From: "Robert Henwood" <rahplanning@bigpond.com>
Sent: Thu, 29 Jan 2026 17:12:12 +1000
To: "Maris-Claire Salazar" <maris-claire.salazar@townsville.qld.gov.au>
Cc: "Bruce Kingsun" <admin@kingsunproperties.com.au>; "Tony Parker" <tony@imcommercial.com.au>
Subject: RFI - 325 Shaw Road Shaw 4818 - Lot 19 SP107219
Attachments: 25-391 site plan - 28-01-2026.pdf, 01_TIA_Shaw.pdf, SK06-09_27.08.2025.pdf

Application no: MCU21/0089.03

Proposal: Change Other to Development Approval associated with MI16/0015

Street address: 325 Shaw Road SHAW QLD 4818

CAMBRAYconsulting

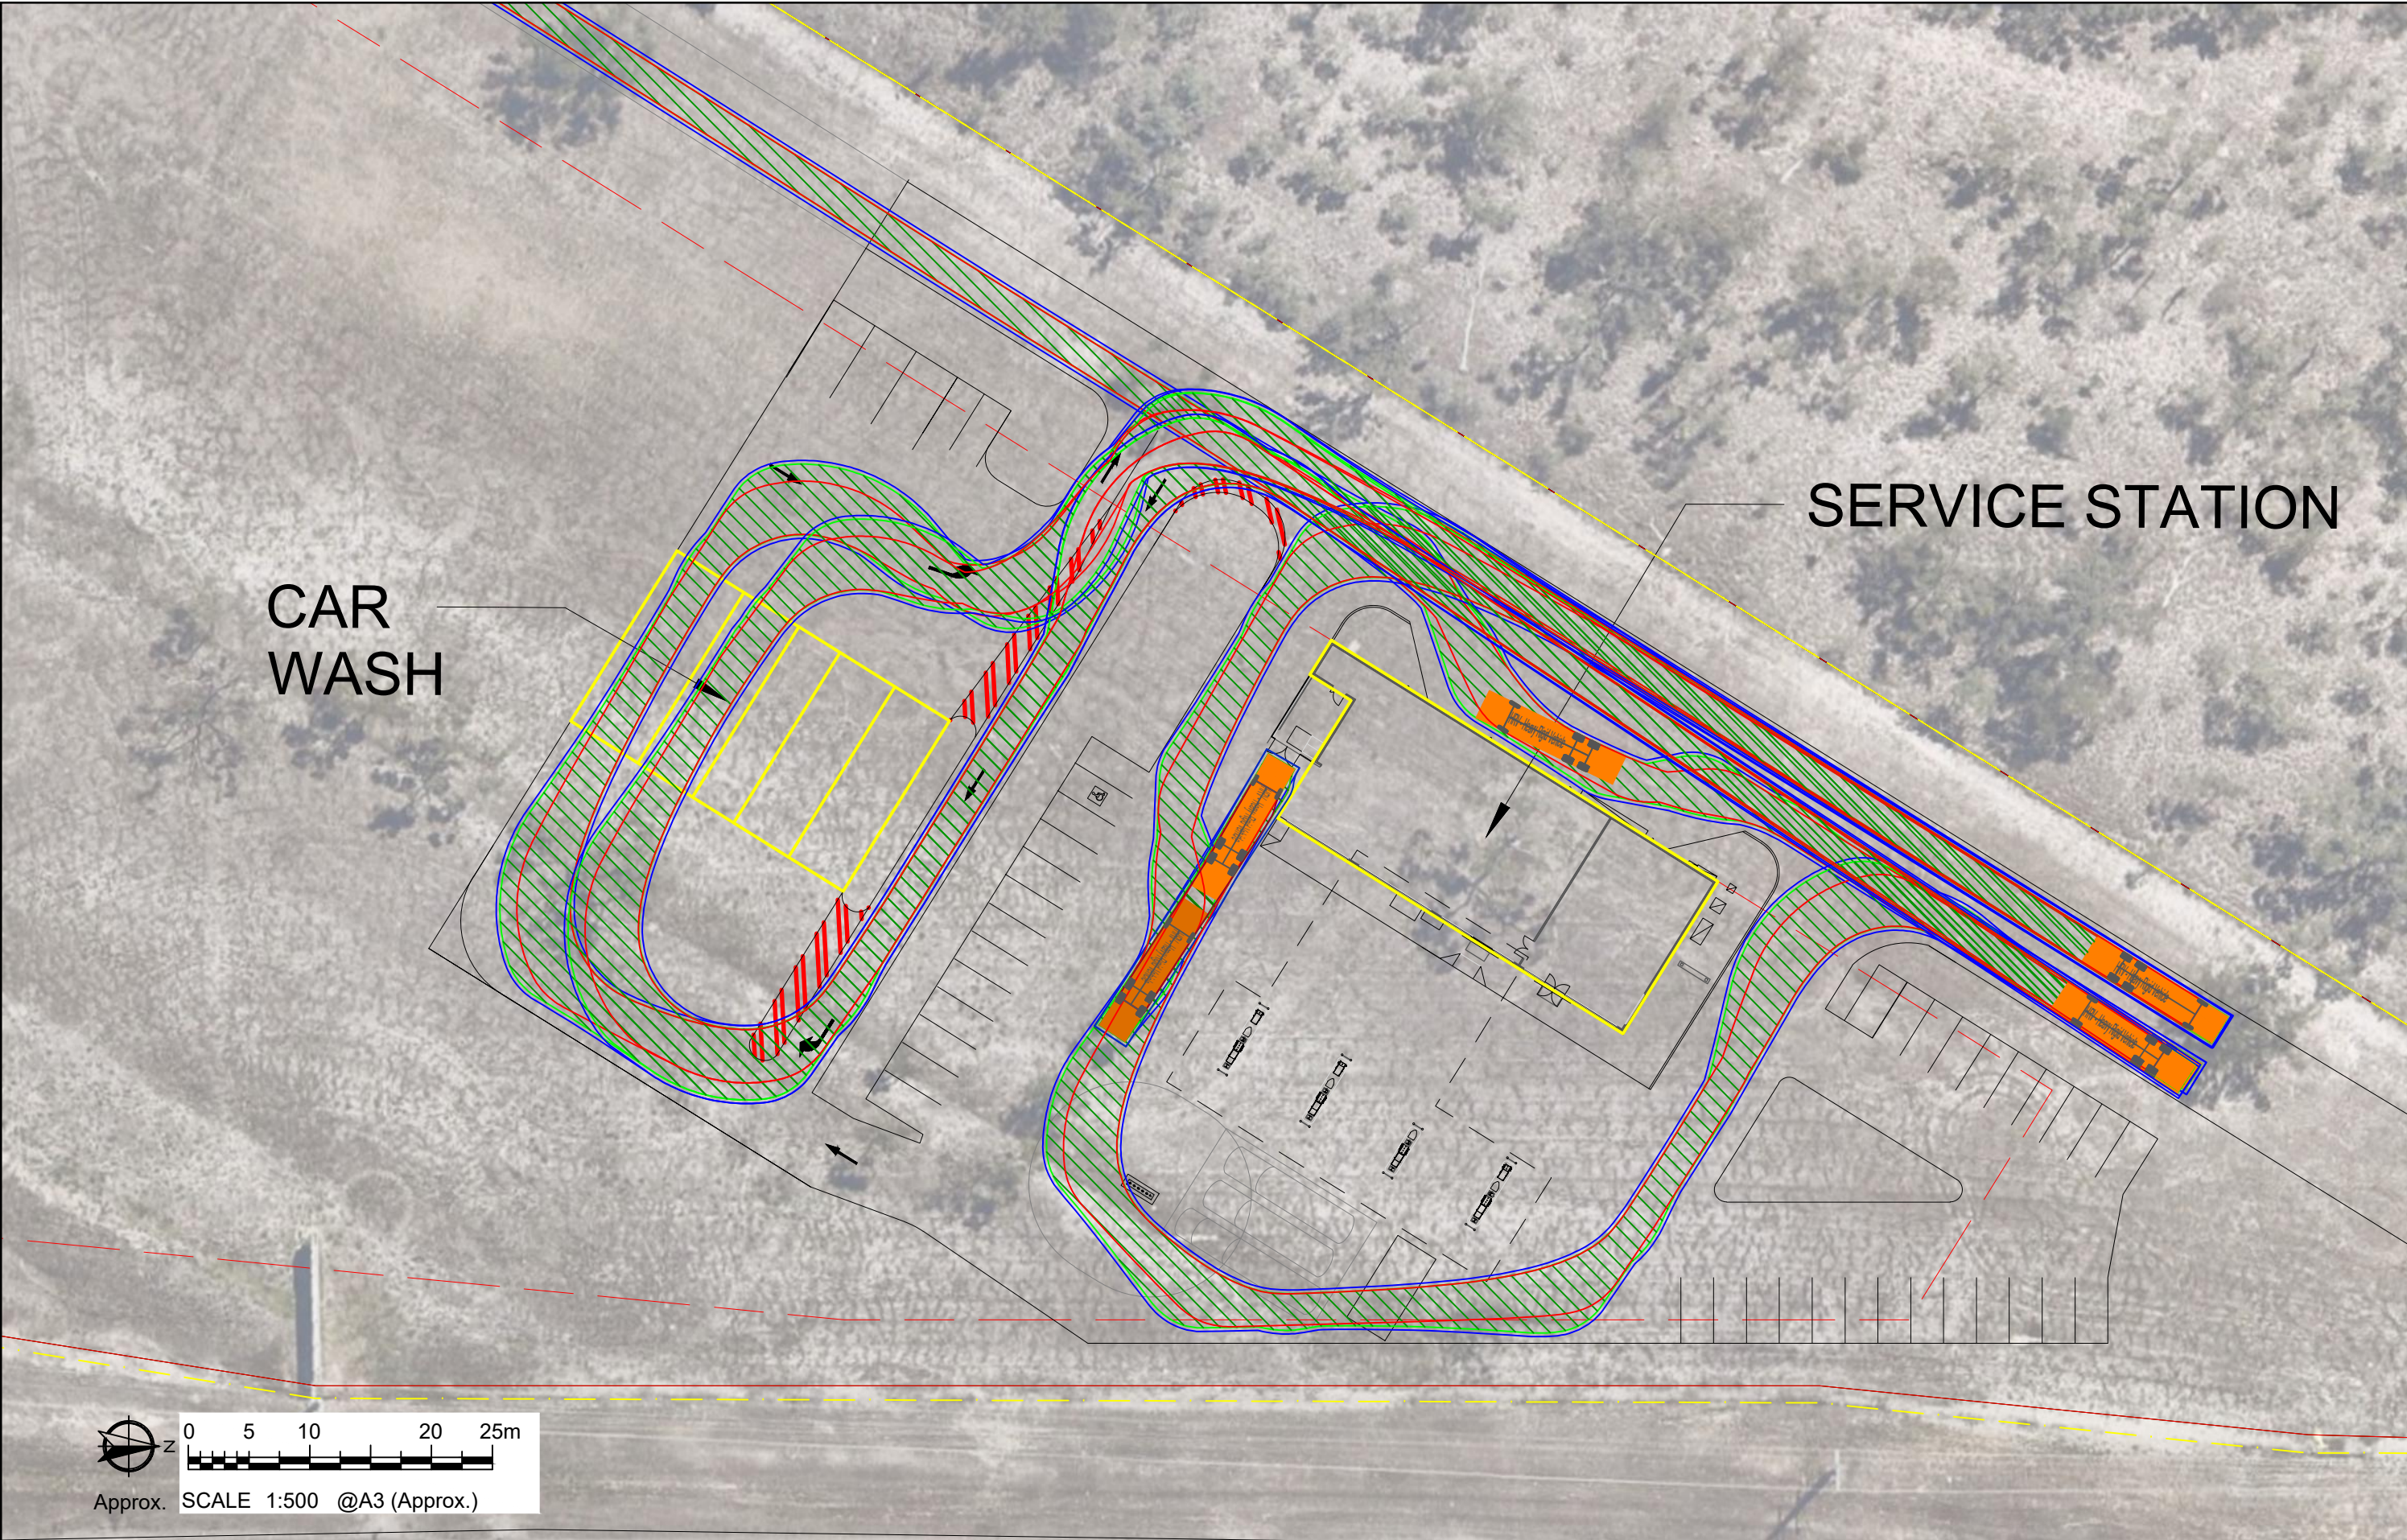
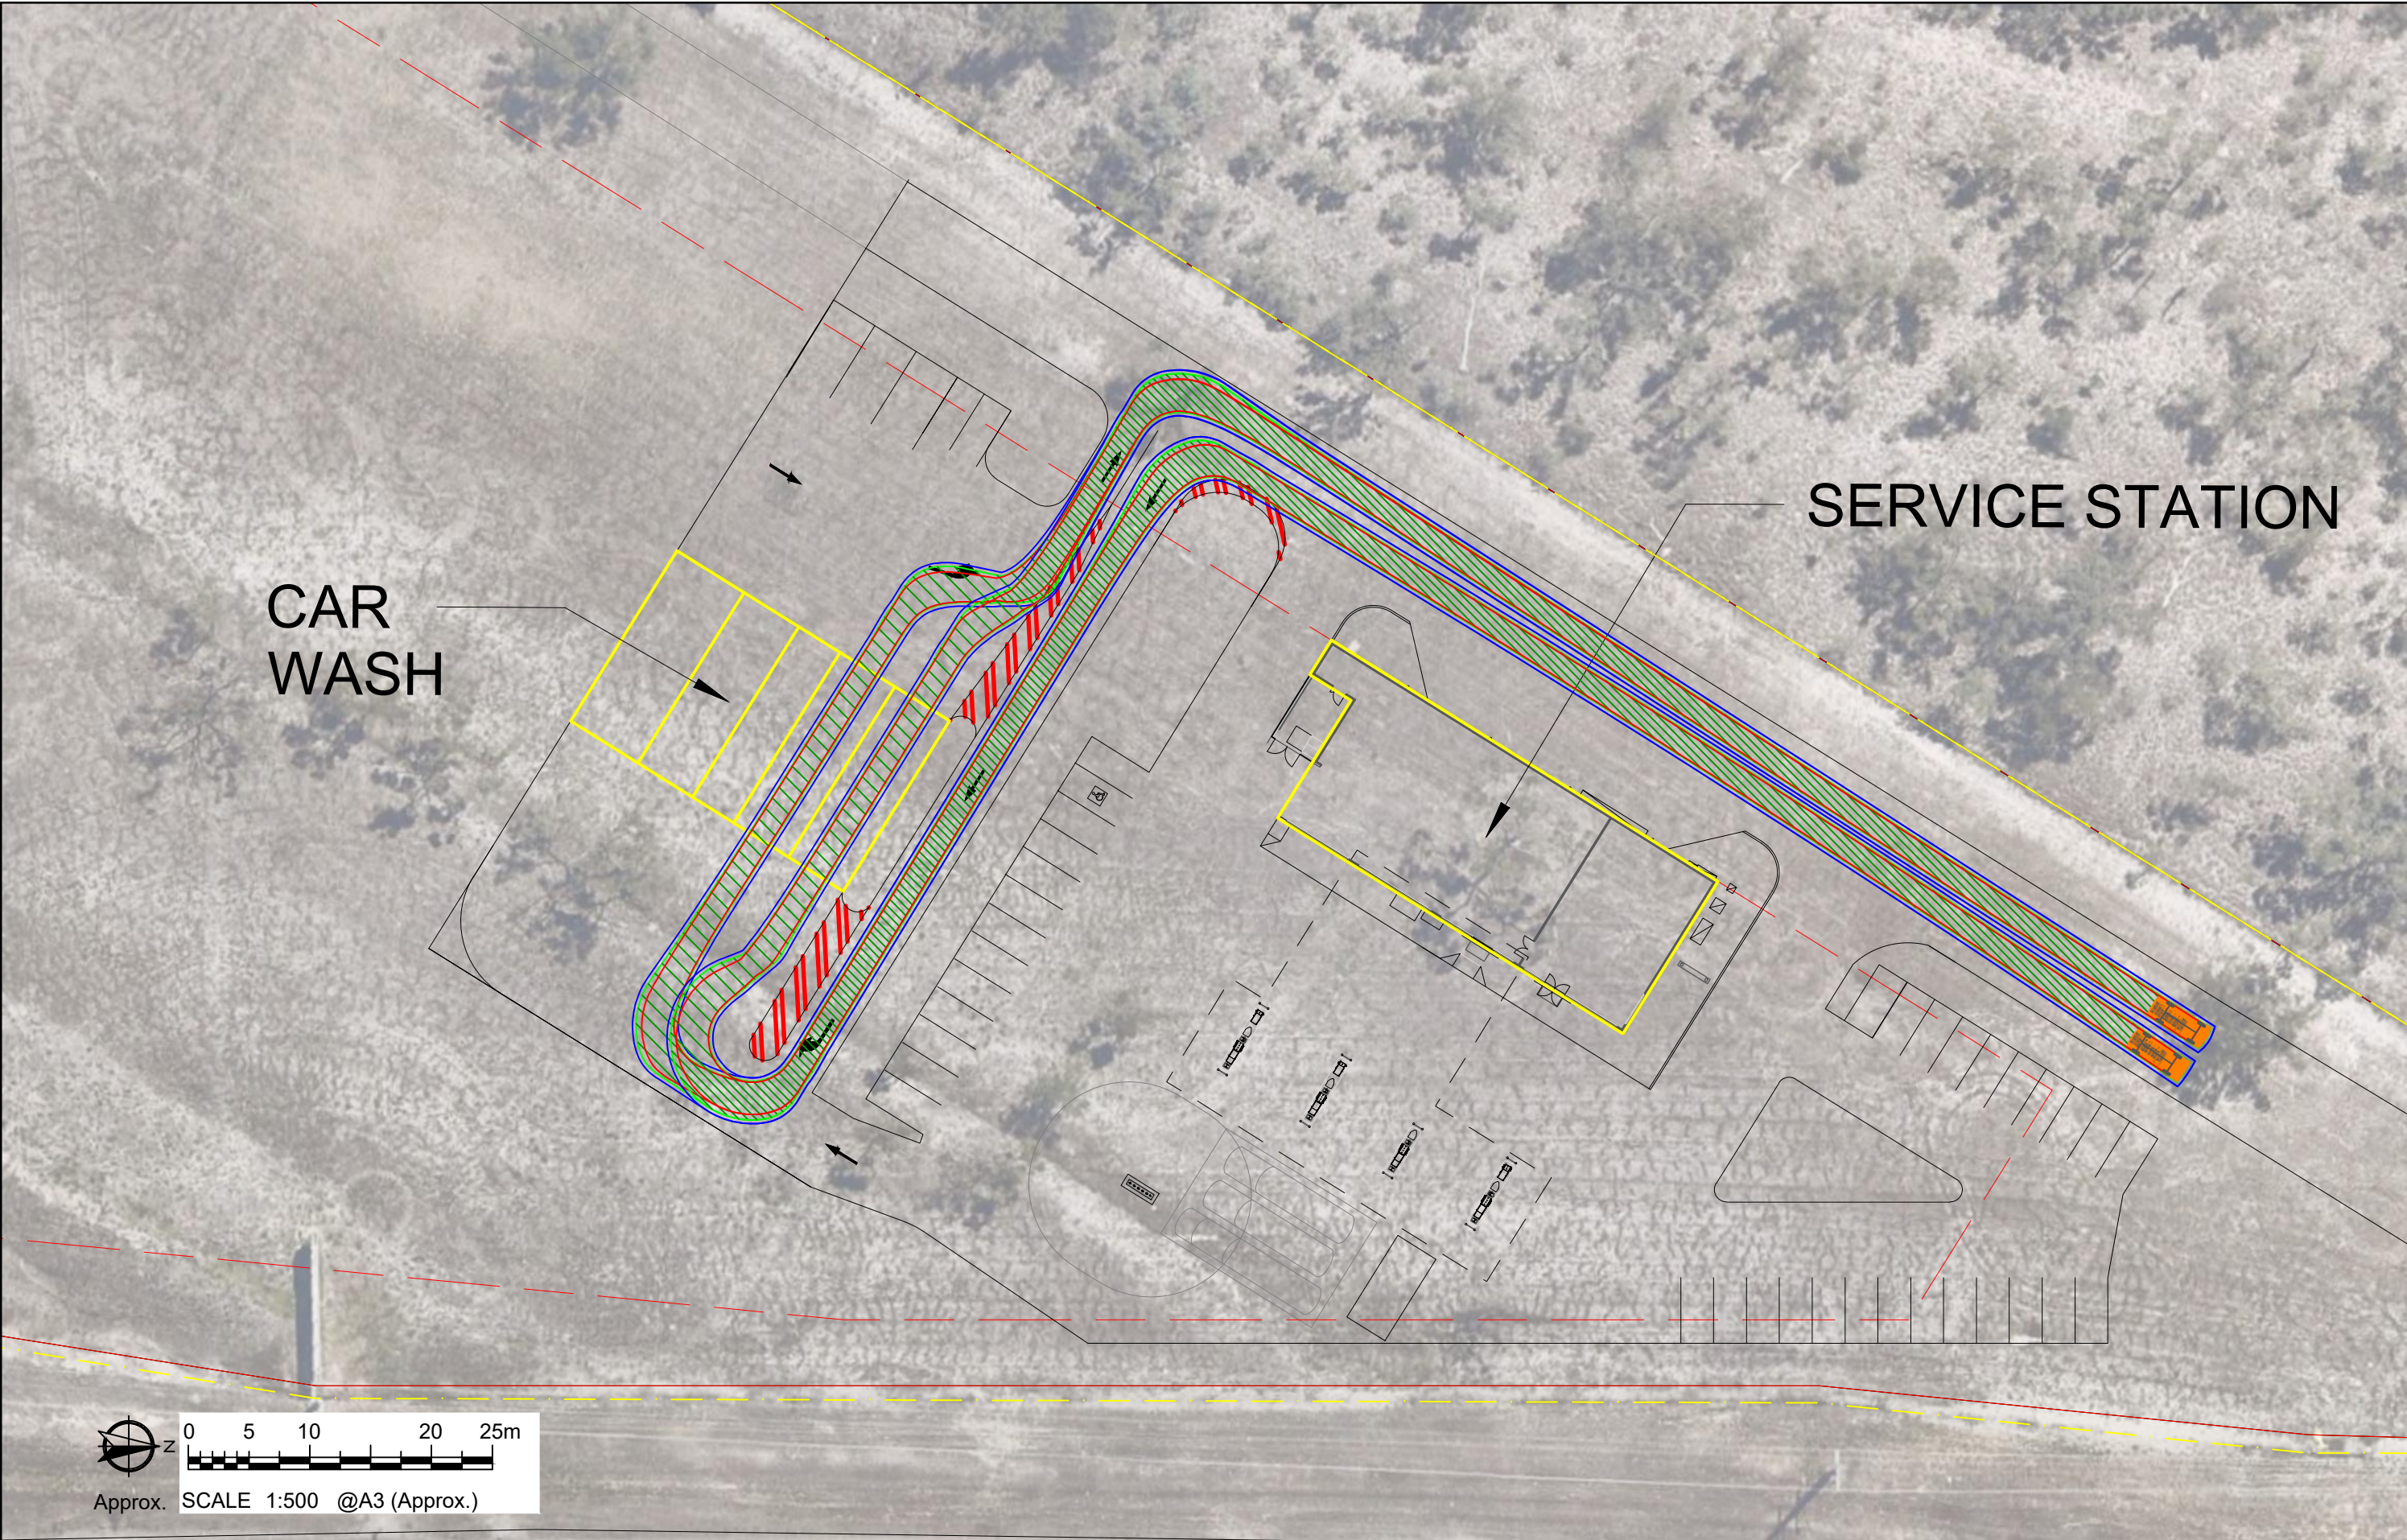
Request Item 3 – Amended Traffic Impact Assessment

The applicant is requested to provide an amended Traffic Impact Assessment to include swept path assessments for all car wash bays.

Attached are the amended Traffic Impact Assessment report and drawings prepared showing the Swept paths to car wash bays etc
